**SEATTLE DEPARTMENT OF TRANSPORTATION
FAIRVIEW AVE. NORTH BRIDGE REPLACEMENT
VALUE ENGINEERING
17 OCTOBER 2014**

This Value Engineering (VE) report is presented to Seattle Department of Transportation and the Pertteet / HNTB team to assist in decision making and completion of design at the 60% design stage. The purpose of the study was to review the current documents and offer constructability and VE refinements that can assist in the advancement of the project and reduce risk.

P1

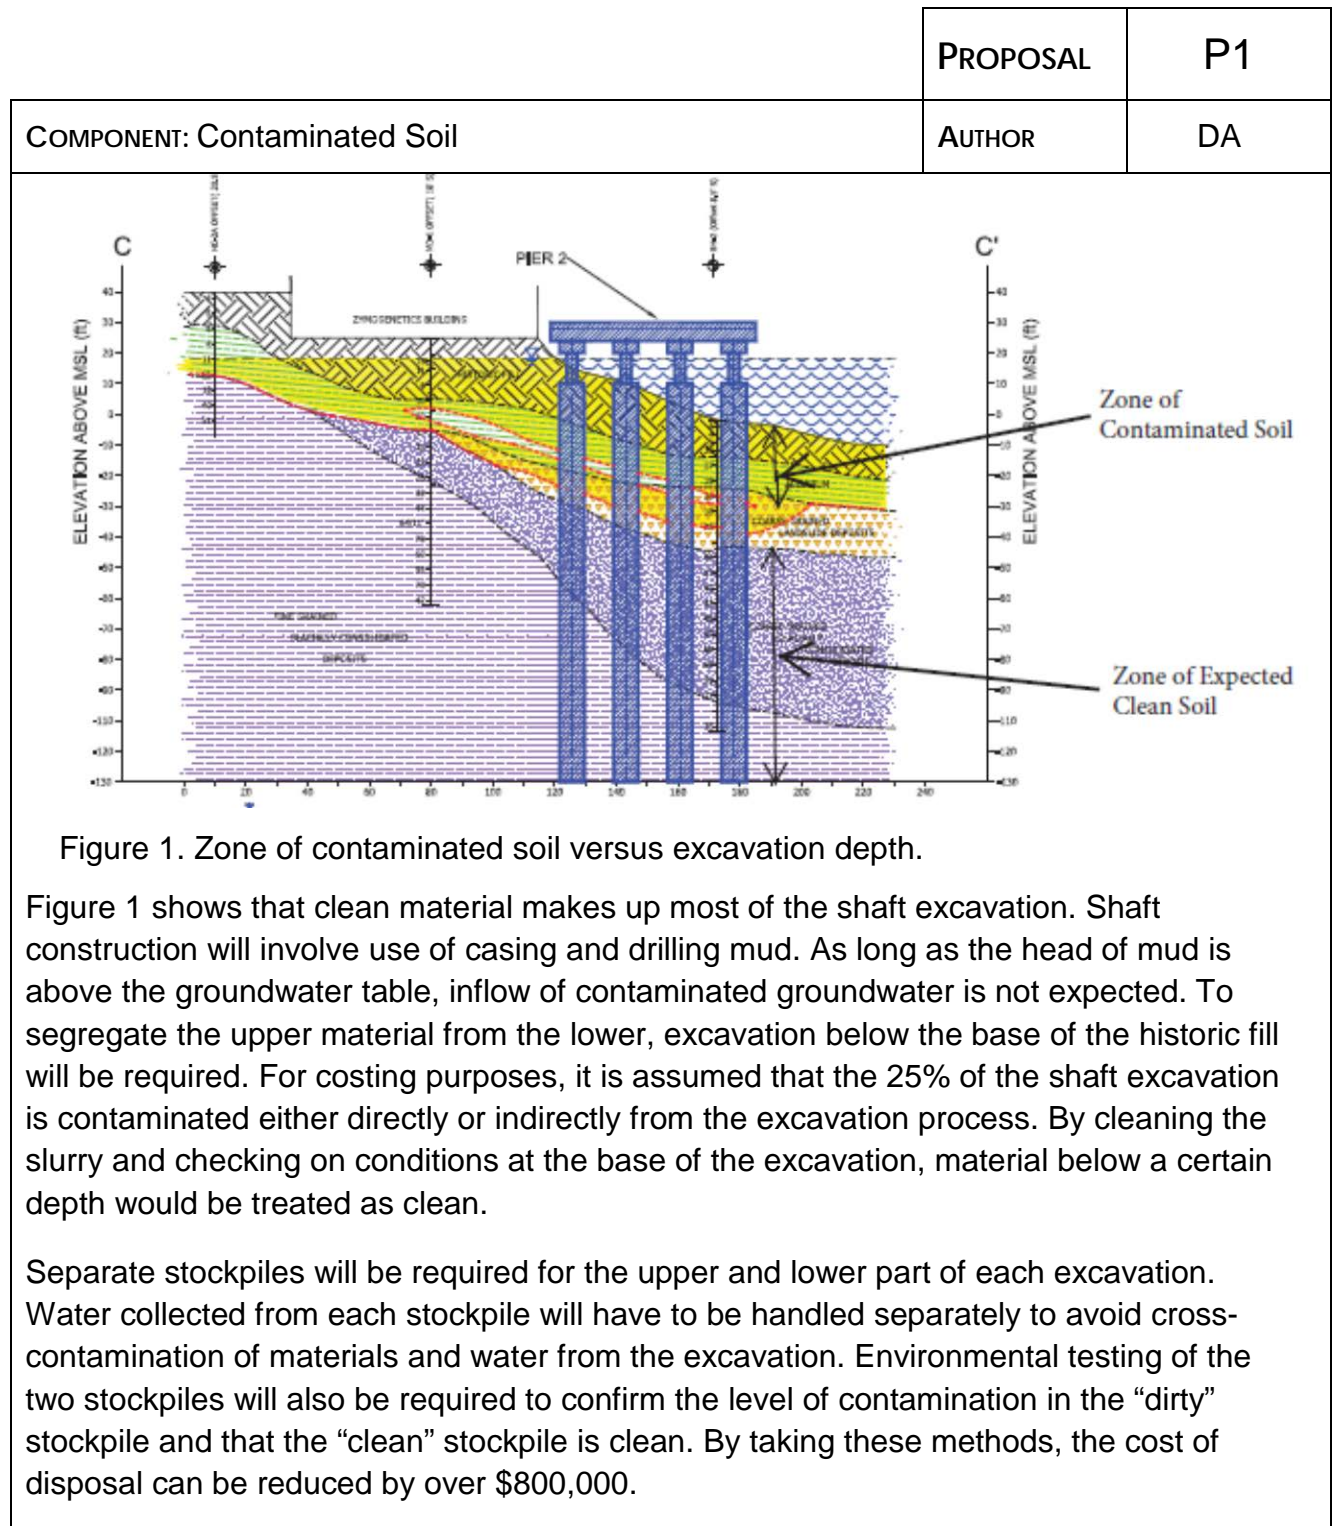
<p>Discussion: The HWA geotechnical report has identified contaminated soils at the site. These contaminated soils are generally located within fill materials found in the upper 15 to 20 feet of soil profile. Native soils below these contaminated soils are understood to be “clean” in the sense that they do not require special handling or disposal.</p> <p>Construction of the drilled shaft foundations will involve excavating through the contaminated soil and into the underlying “clean” soil. The depth of shaft excavation will</p>

PROPOSAL	P1
COMPONENT: Contaminated Soil	AUTHOR	DA
<p>be approximately 140 feet below the ground surface. Rather than trying to separate the upper 20 feet of contaminated soil from the deeper “clean” soil, all excavated material is being treated as contaminated. This results in disposal of 9,000 tons of excavated soil at a permitted landfill facility. The estimated cost of disposal is \$110/ton.</p> <p>This proposal recommends separating the contaminated soil located in the upper 15 to 20 feet of soil profile from the underlying clean material. By segregating the materials, the cost of contaminated soil disposal is reduced.</p> <p>Although the idea of segregating soils is conceptually simple, implementation of this approach requires</p> <ul style="list-style-type: none"> • The ability to determine in the field whether soils are suitable for clean disposal • The ability to keep dirty material separated from clean material as it is stockpiled before transport. • The ability to seal the shaft excavation from infiltration of contaminated groundwater as the shaft is being excavated. <p>While these constraints on the contractor’s means and methods are significant, they have been used on other major projects, such as the Gerald Desmond Bridge in Long Beach California.</p> <p>Successful segregation will require sufficient area in proximity of the existing bridge to create separate disposal areas. In view of the limited space within the project limits, the only practical approach for implementation of this proposal will be if there is full closure of Fairview Avenue.</p>

P4

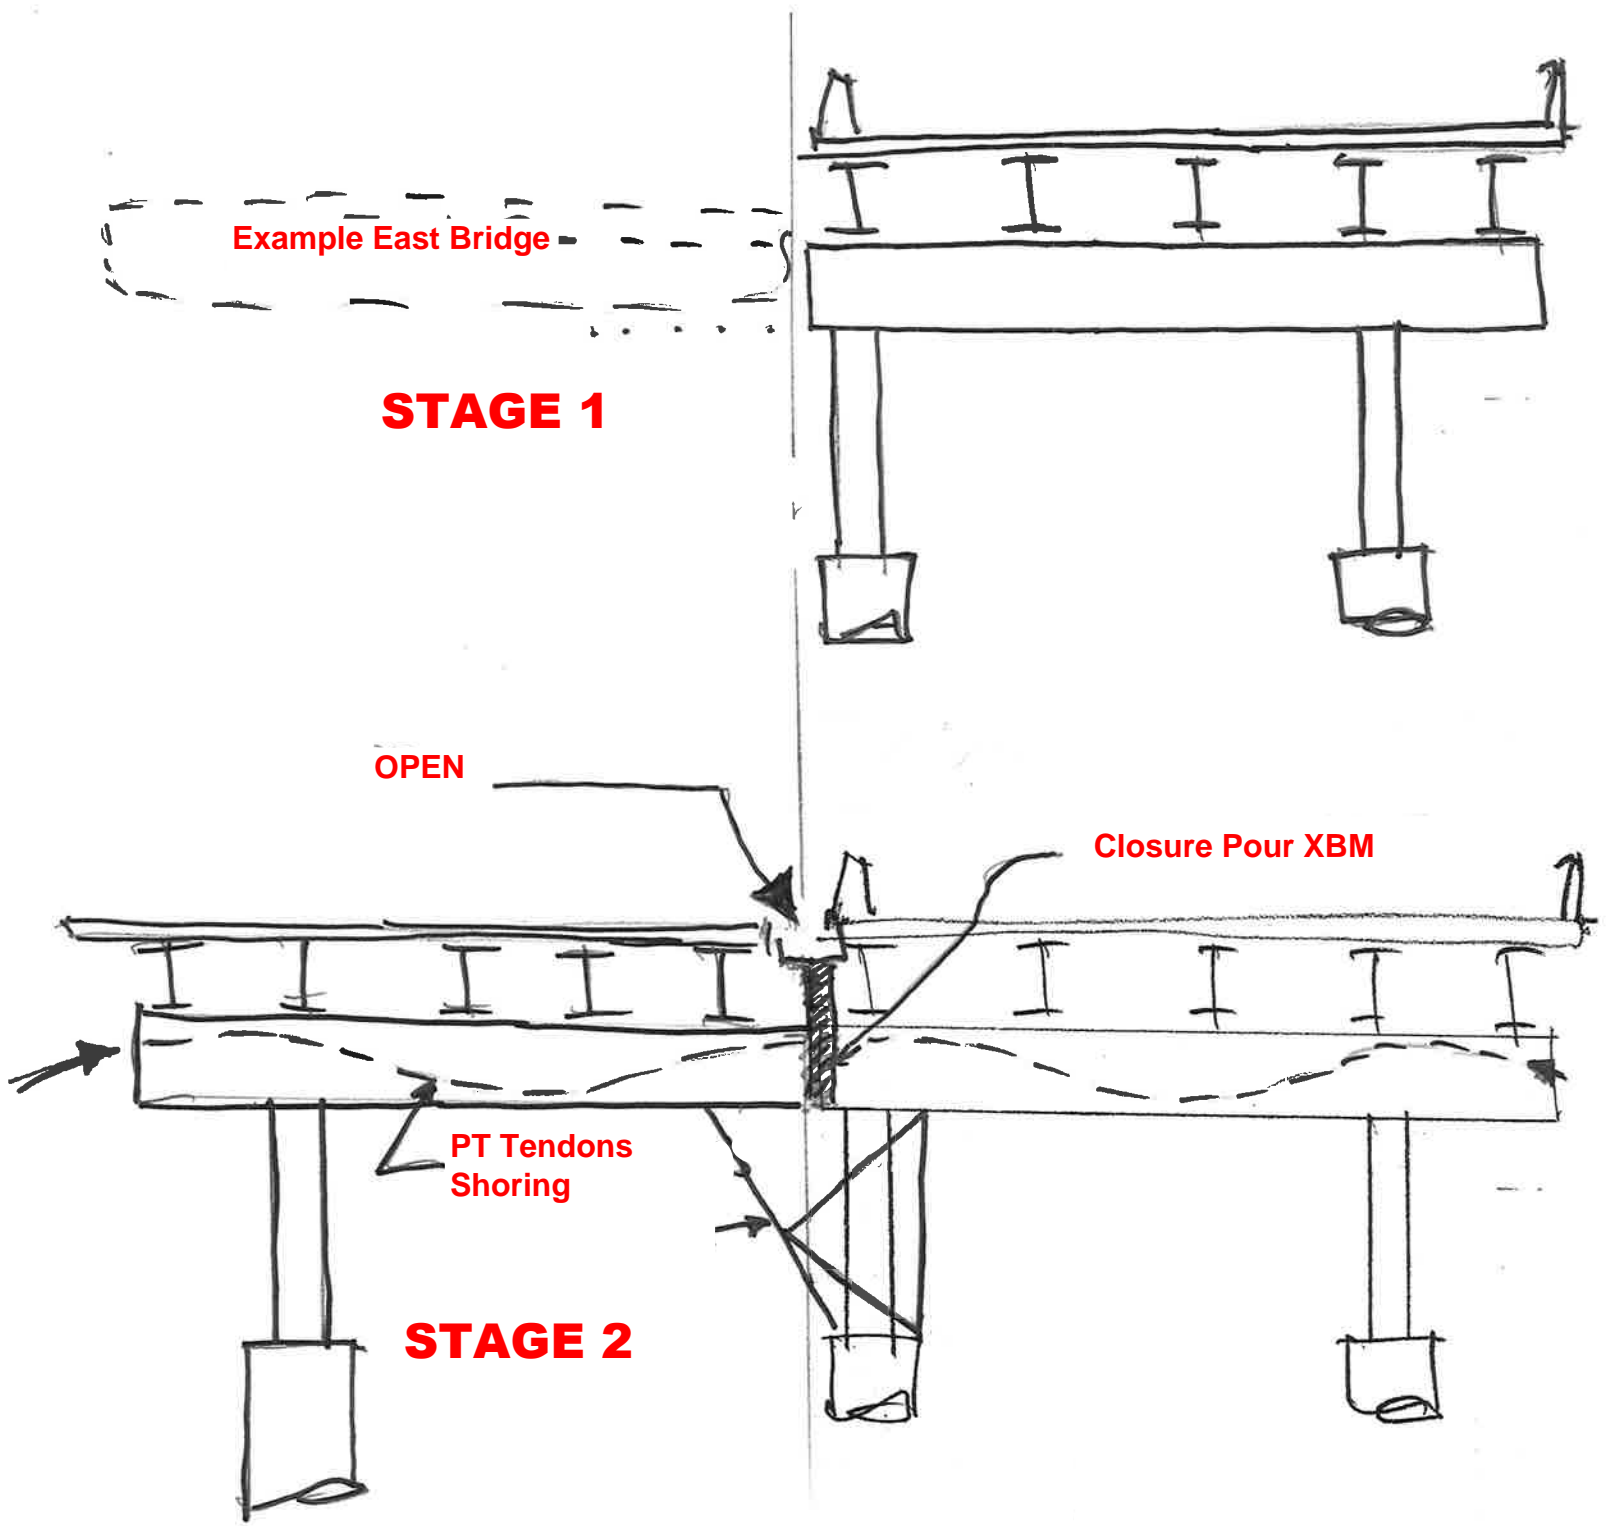
PROPOSAL	P4
COMPONENT: Structure	AUTHOR	DWK
CURRENT CONCEPT: A two-stage construction process with both stages on bridge halves, having two columns and drilled shafts per pier.		
VA CONCEPT: Maintain the two-stage construction concept, but reduce the shaft and column number to three per pier.

DISCUSSION: In order to facilitate stage construction, two column bents are being placed under each stage. This is normal and good practice. This shaft reduction method applies to two phase construction only. Since the drilled shaft costs are so high, reducing the number of shafts is advisable. Changing the piers to a three column bent, and post-tensioning the crossbeam is proposed. This will involve a more complicated falsework and shoring system under the

<p>Figure 1. Location of ZymoGenetics Building relative to bridge reconstruction.</p>

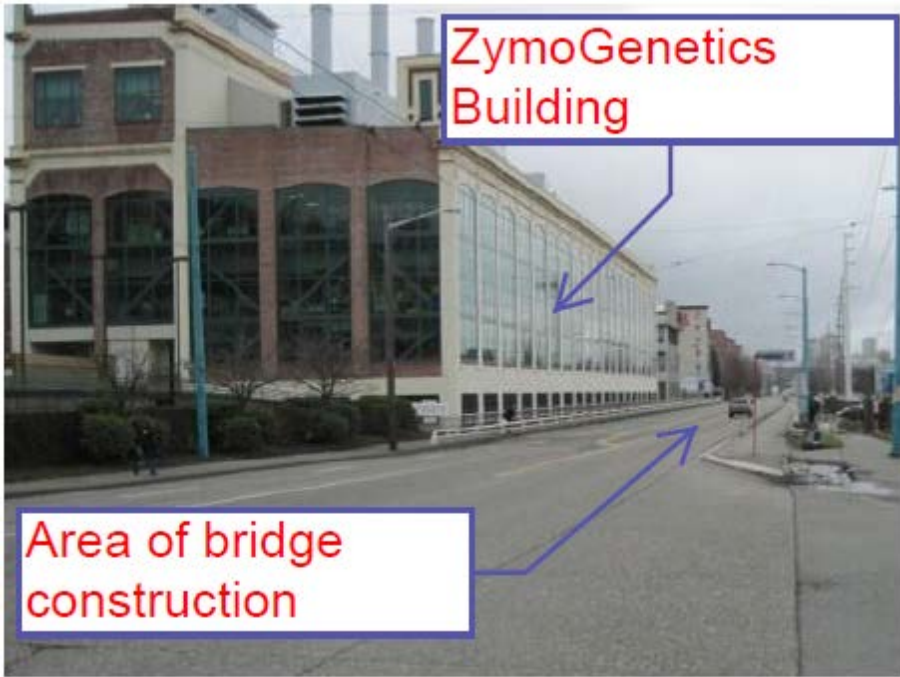
TECHNICAL REPORT	PROPOSAL	T3
COMPONENT: Vibration	AUTHOR	DA
<p>CURRENT CONCEPT: Construction methods that limit the potential for construction vibrations are identified by the design team. These constraints are placed on construction because of the sensitivity of the ZymoGenetics' operations to vibrations. Affected construction methods include shaft construction, installation of sheet-pile walls, and ground improvement methods – amongst others.</p>		
<p>CONSIDERATIONS: The ZymoGenetics Building is located within 10 feet of the east side of the Fairview Bridge. The proximity of the building makes it susceptible to construction vibrations. The VE team understands that the designers have been in discussions with ZymoGenetics and have learned that ZymoGenetic operations have no tolerance for vibrations. Furthermore, the design team reports that the nature of ZymoGenetics operations is such that their facility must be vibration free at all times – 24 hours a day – and that there are no periods during planned bridge construction when the ZymoGenetics facility can relax their vibration requirements.</p>

TECHNICAL REPORT	PROPOSAL	T3
COMPONENT: Vibration	AUTHOR	DA
<p>The sensitivity of the ZymoGenetics operations has resulted in a number of construction constraints. For example:</p> <ul style="list-style-type: none"> • Vibratory methods for installing shaft casing are not allowed according to the 60% special provisions. Wording within the special provisions implies that an oscillator should be used to excavate the shaft. • Piles to support a work bridge will be drilled piles, rather than a more conventional approach of installing piles by vibratory methods. • The most likely method of ground improvement – stone columns – was abandoned because of the vibrations normally associated with compaction of the stone in the column. In its place, a non-vibratory stone column method was initially considered. However, the costs and space requirements associated with a non-vibratory stone column method led to dropping this idea. <p>Specific limits on vibration levels within the ZymoGenetics Building or during construction of the Fairview Avenue Bridge have not been identified, as far as the VE team is aware. Normally these limits include peak particle velocity (PPV) and its variation for predominant frequency of vibration. Various general criteria have been developed to give general limits. These criteria show that the levels of PPV to cause structural damage can be in excess of 1 inch/second. On the other extreme, historic structures may be damaged at levels of vibration of less than 0.1 inches/second. Actual limits will vary according to soil support, frequency, and construction method.</p> <p>The VE team believes that a detailed review of vibration requirements could be beneficial to the project. This review needs to establish the manner in which vibrations created along the alignment of the bridge during construction propagate through the soil and piles supporting the ZymoGenetic Building into the various levels of the building. The combination of soil and timber piles would normally be expected to attenuate the level of ground shaking and therefore levels of vibration will be lower than at the source of vibration.</p>

Figure 2. Path of vibrations from construction into ZymoGenetics Building.

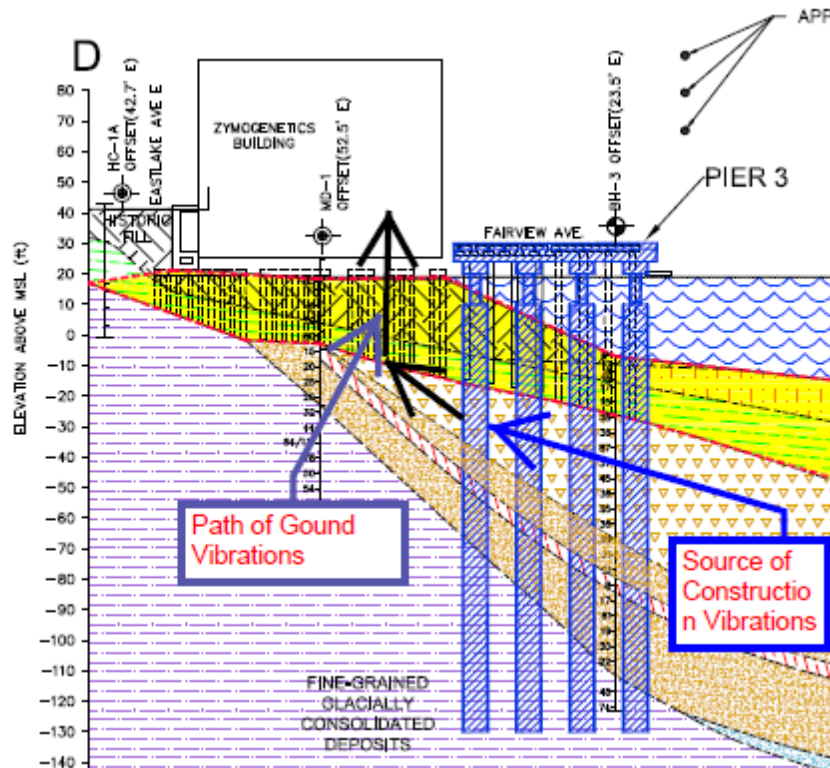
The quantification of vibration levels will require a systematic evaluation of the sources of vibration, attenuation of vibration levels through the soil, and propagation into the building. This evaluation is best made through a monitoring program where levels of vibration near and within the building are recorded for a number of different vibration sources along Fairview Avenue. The sources should include heavy trucks and Metro Bus traffic and controlled source generation. Vibrations should also be monitored throughout demolition of the Gunn Building. Data collection and interpretation should include peak levels of ground velocity and frequency, as well as Fourier analyses of the data to understand frequency distributions. Correlations between the source, distance, and levels of vibration should be developed.

As part of this monitoring program, representative vibration levels should also be established for construction methods such as: oscillator versus casing/auger methods of drilled shaft construction, for ground improvement using standard stone column methods,
